Access Compliance Report

Public Rights-of-Way

(Pedestrian Signals)

Intersection ID: N/A	Main Street:	Cross Street: N/A	Location: N/A
ADA ID: 686DB71FC7C1	Signal Type: One Push Button-APS	Overall Compliance: No	Severity Score: BTN 1: N/A BTN 2: N/A No BTN: N/A
Codes/Mitigation Info/Possible Solution		Field Measurements/Component Compliance

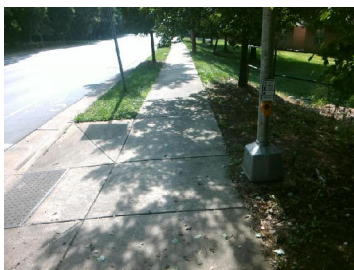
Surveyor Notes: TEXT HT 3/8

PROW/ADA: R410.6, TMUTCD 4e.08, R209.1, MUTCD 4e.10

Possible Solutions: Replace Signal Push Button With APS Button on New Post. Remove & Replace Sign.
